RE: **GAHP Silver Downtown**
800 Silver SW
Grading Plan Engineer's Stamp Date: 2/21/2017
Hydrology File: K13D013

RE: **GAHP Silver Downtown**
800 Silver SW
Grading Plan Engineer's Stamp Date: 1/30/2017
Hydrology File: K13D013

Based upon the information provided in your submittal received 2/10/17, the Grading Plan is not approved for Building Permit. The following comments need to be addressed for approval of the above referenced project:

A4 OVERALL GRADING PLAN
1" = 20'-0"

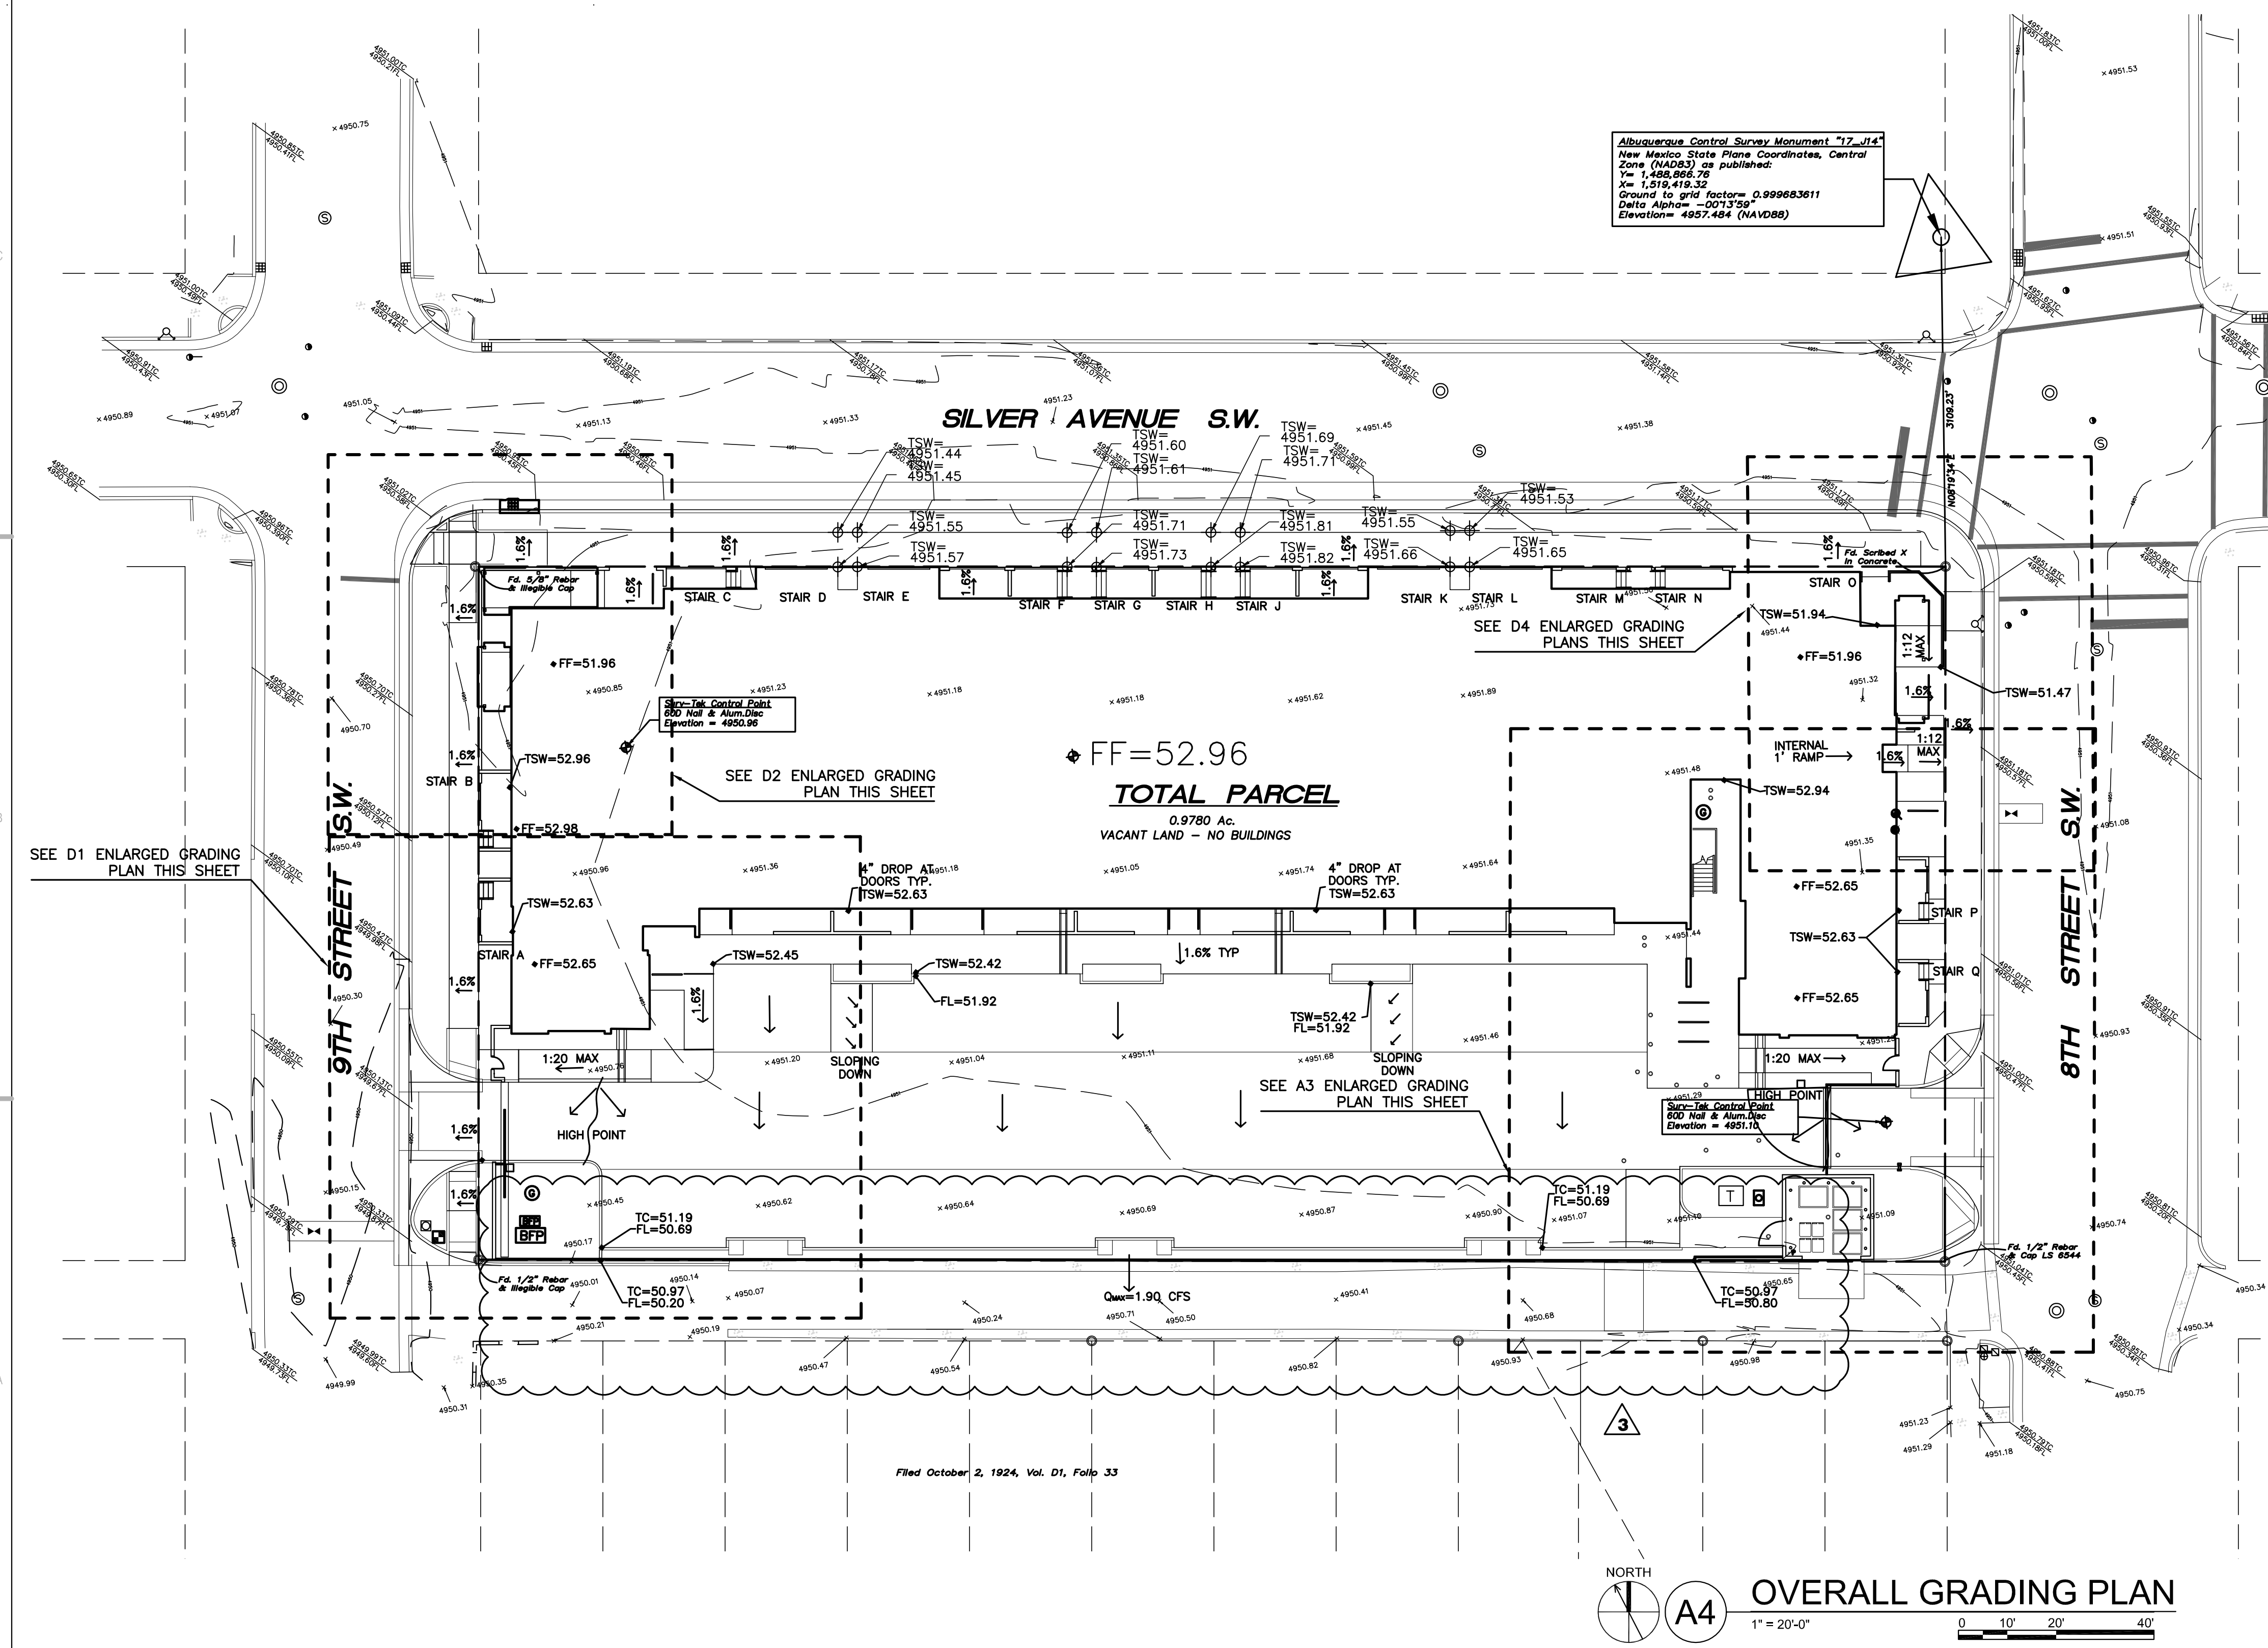
3. There is a reference to a constrictor plate for the draining the parking lot to the ally, but none is shown on the construction plans. Provide location and details for this.
Constrictor plate no longer used. Setting curb height to limit ponding.

4. It was agreed during the review for SPBP that the wide buffer between the back of curb and the edge of sidewalk would be used to help mitigate nuisance ponding on Silver and 9th Street, by including new curb cuts on the ex. curb. This would help the site achieve the capture of the first flush volume. It needs to be shown on the plan.
No longer possible due to fire marshal requests.

5. The 2" depression in the sidewalk buffer does not account for the running slope along top of curb and along the sidewalk. This means the depression will not retain a uniform 2" deep pool. This area needs to be supplemented with a 5:1 gravel filled swale and curb cuts with shallow ponding to allow in flows from Silver and 9th Street.
9th Street and Silver to have 5:1 swales.

6. The ponding volume for the parking area does not account for the running slope across the parking lot toward the ally. This means the gravel areas will not retain a uniformly deep 2" of water.
and curb opening on 9th Street.
Volumes adjusted. 5:1 slopes added.

This was adjusted to account for slope. 2" to centroid of volume retained

A5 ENLARGED GRADING PLAN
1" = 10'-0"

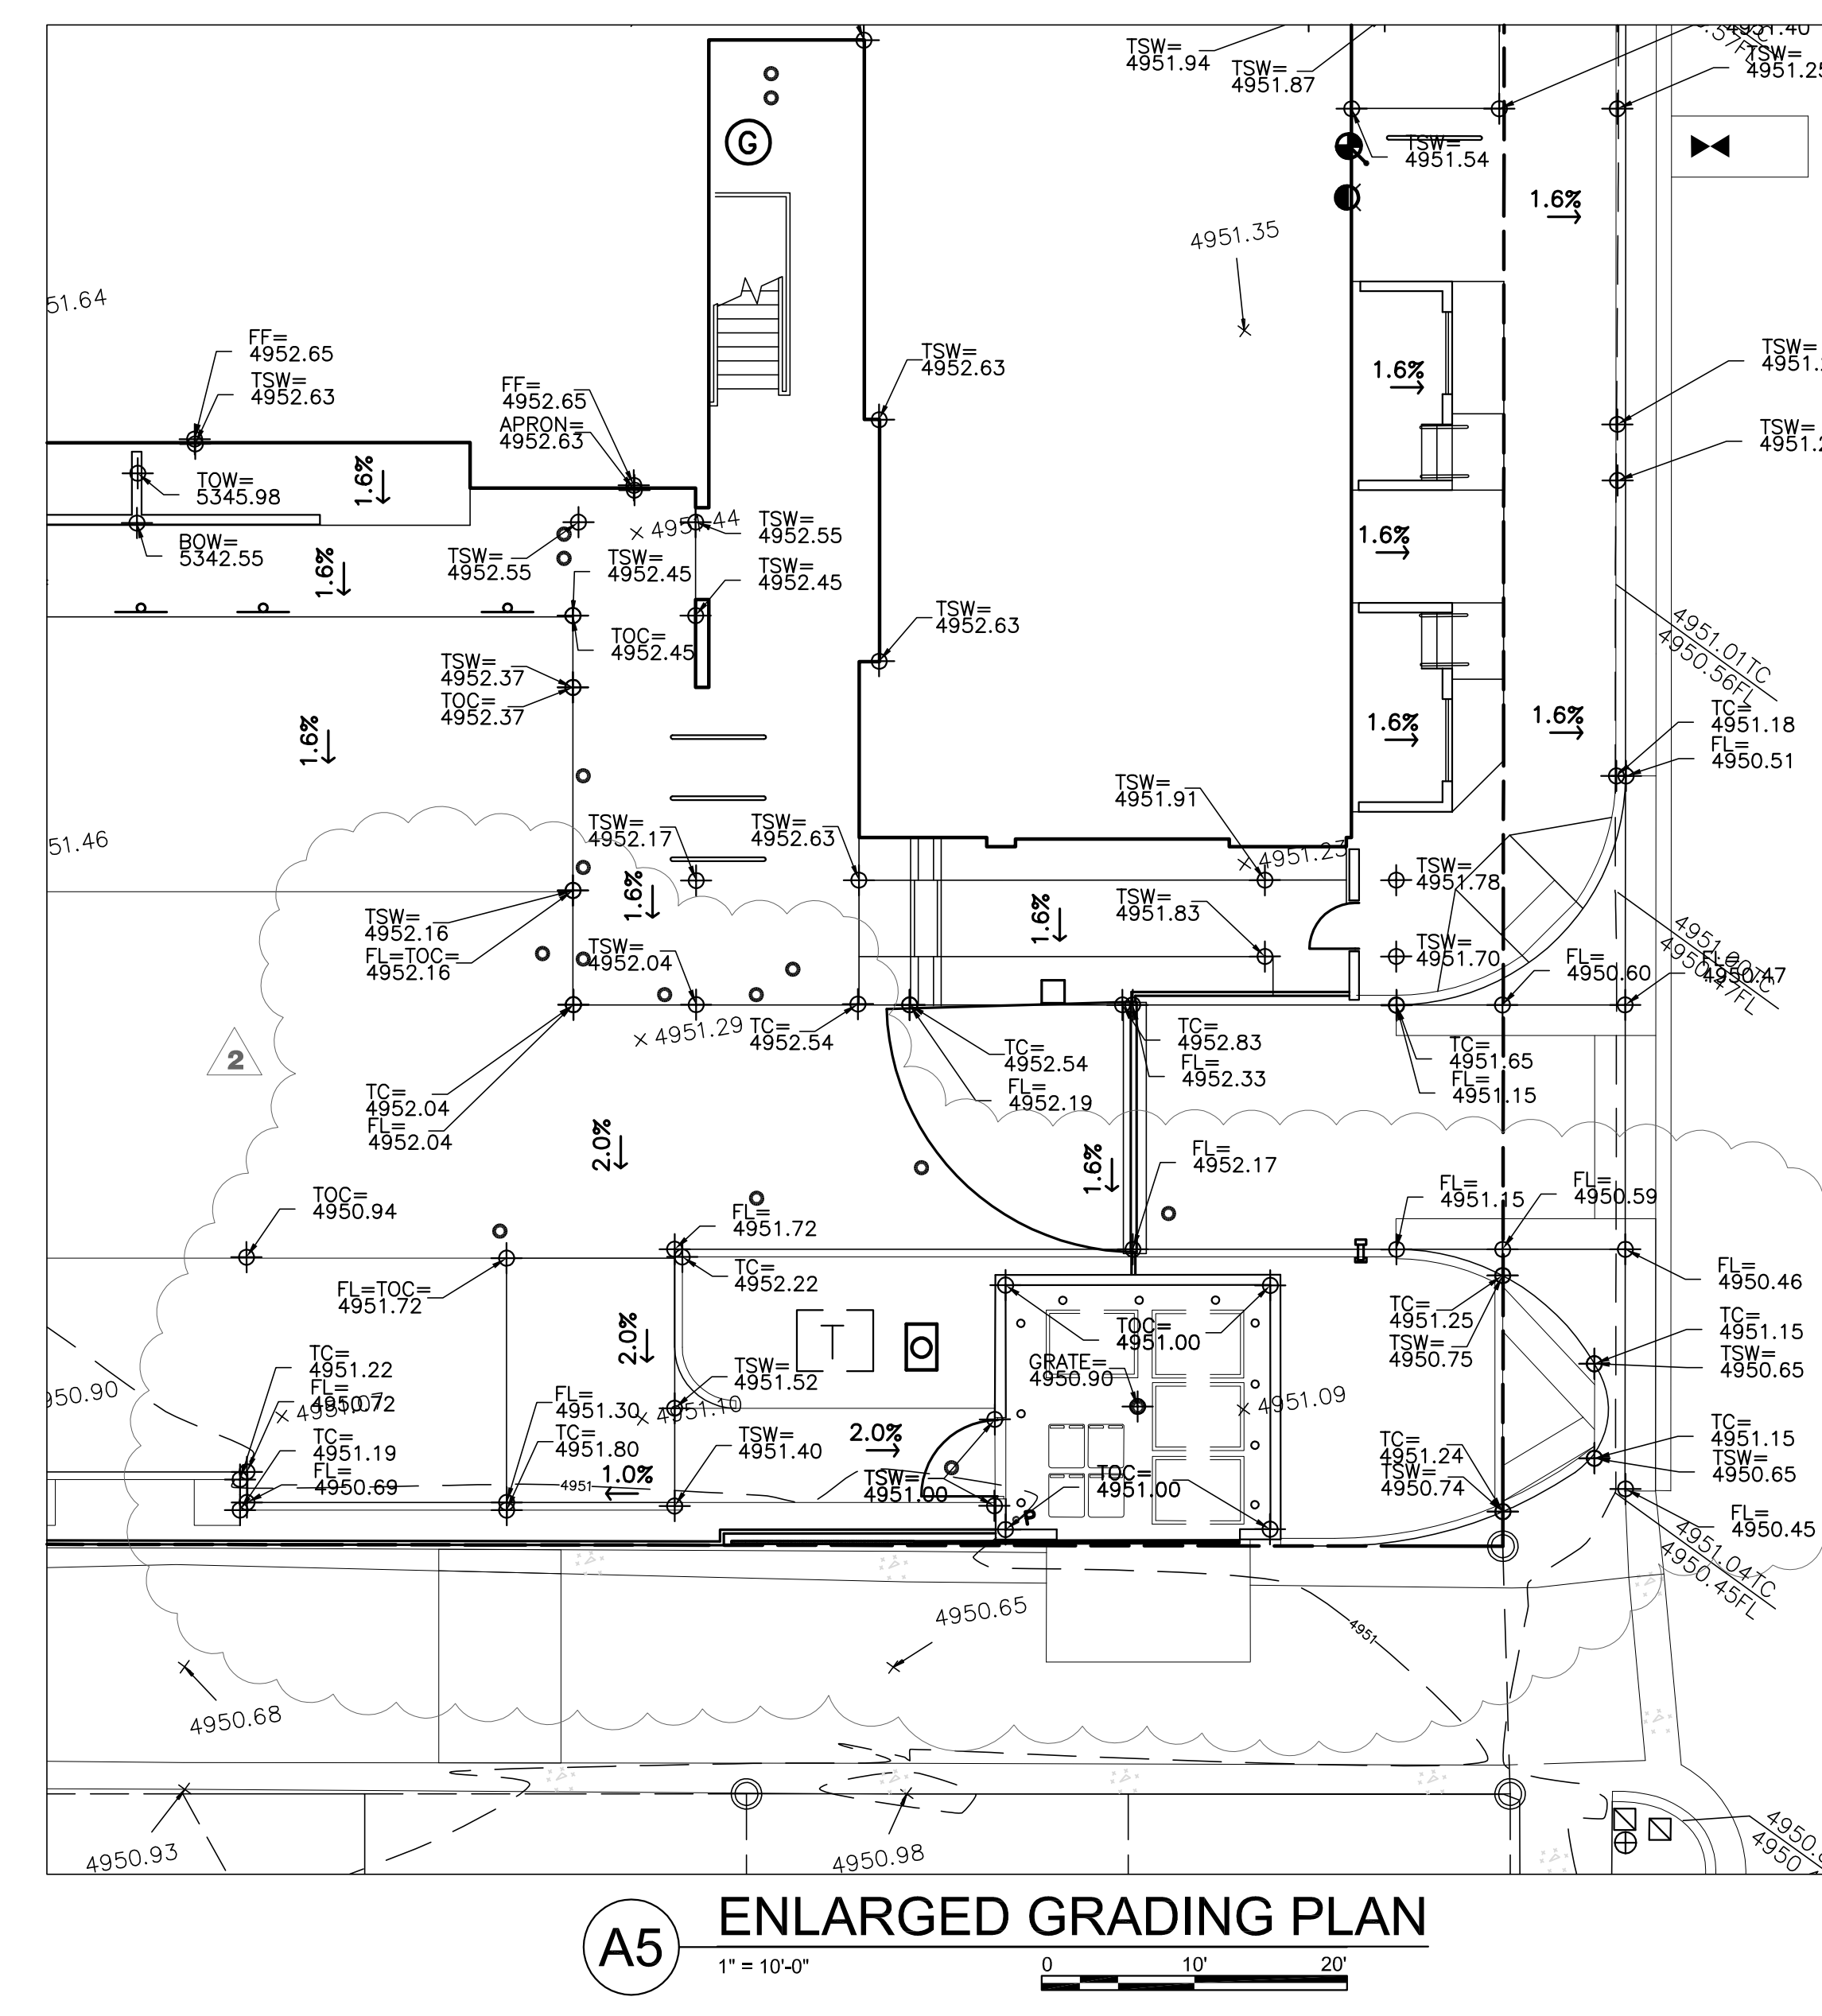
7. There is a grate elevation shown in area A5. Is there an interior storm drain network or is this to plumb the trash area into the sanitary sewer?

Notes added that this drains to sanitary
